NOTICE OF PROPOSED DEVELOPMENT

4 OCHRE COURT, DODGES FERRY

DWELLING AND OUTBUILDING

APPLICATION NO: 5.2025-340.1
DATE: 12 JUNE 2026

SHADOW PLAN				SCALE NTS	DATE 01.04.25
							DRAWN paw	DRAWING A1.3

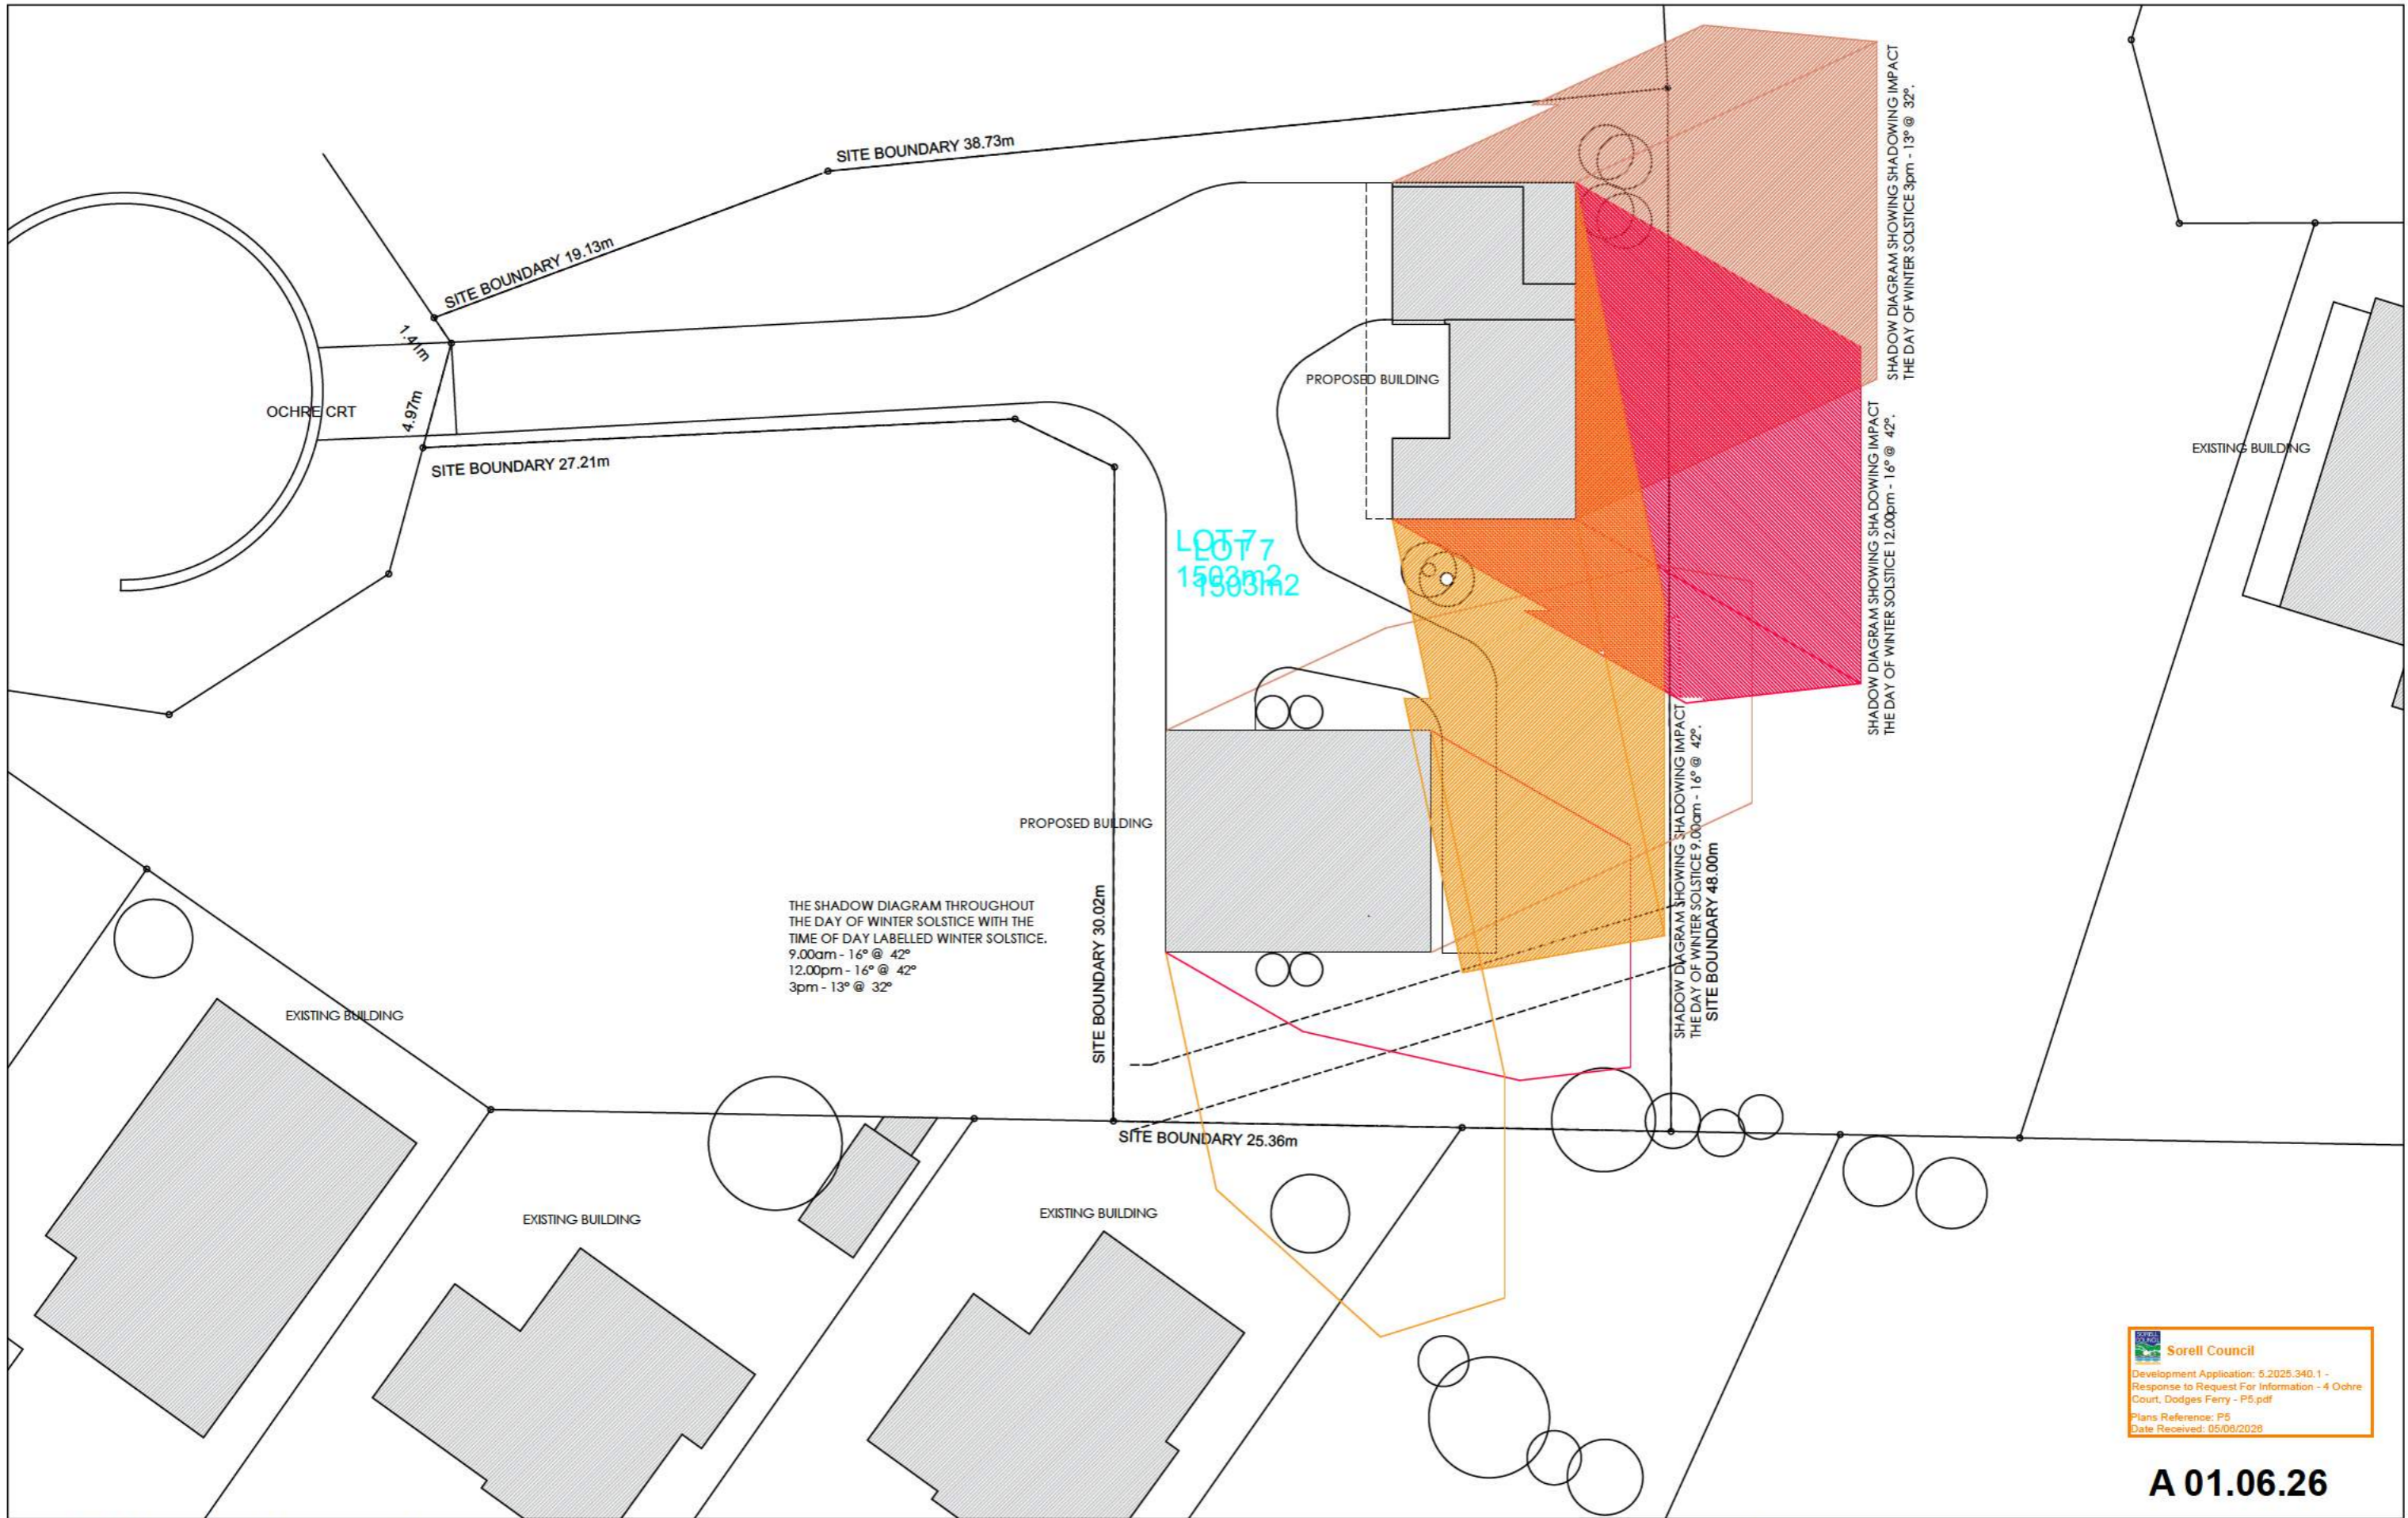
Documentation to address the requirements of Clause 10.4.3 (P2) of the Tasmanian Planning Scheme – Sorell (the Scheme) for setback, specifically in that diagrams to show the likely extent of overshadowing to occur at Winter Solstice because of the proposed outbuilding and residence are required.

Not Satisfied – this requirement remains, and updated shadow diagrams are required that show how the shadowing from both revised buildings would impact adjacent land at the winter solstice.

Please find attached Drawing A1.3 and A1.4 Shadow Plans for proposed outbuilding and residence as requested for extent of overshadowing on the winter solstice at 9am, 12pm and 3pm.
